To: T10 Technical Committee
From: Rob Elliott, HP (elliott@hp.com)
Date: 18 October 2004
Subject: 04-339r0 SAS-1.1 Remove minimum ALIGN counts from summary table

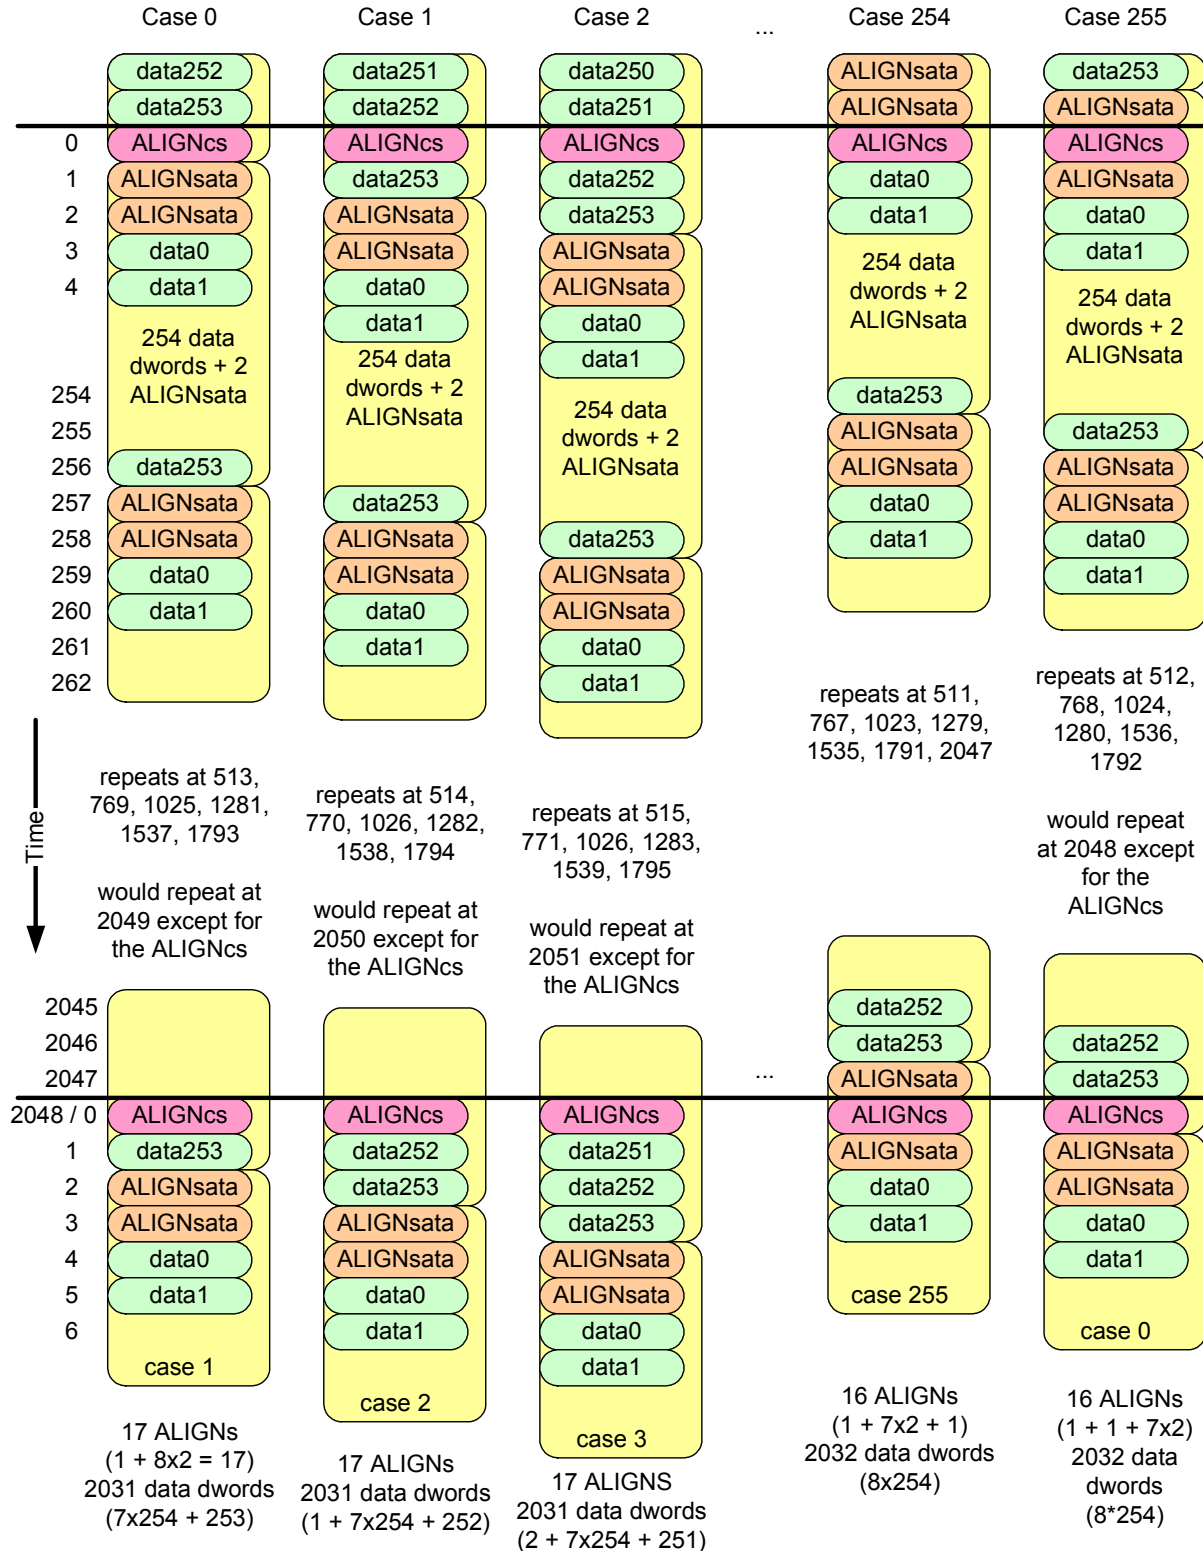
The minimum number of ALIGNs summary column in Annex G provides incorrect numbers for the STP entries.

For example, the 17 ALIGNs per 2048 dwords at 1.5 Gbps physical link rate and 1.5 Gbps connection rate is not always correct; as shown in the following figure, the count actually alternates between:

- 1) 17 ALIGNs for 2046 overlapping windows of 2048 dwords; then
- 2) 16 ALIGNs for 2 overlapping windows of 2048 dwords.

The example in the figure assumes that the ALIGNs for SATA are sent together within each 256 dwords, although that is not necessarily the case for STP; no matter when then are sent, the result is the same.

This affects the STP entries for the 3.0 Gbps physical link rate with both connection rates as well.

Since the actual numbers are complicated, simply remove the offending column.
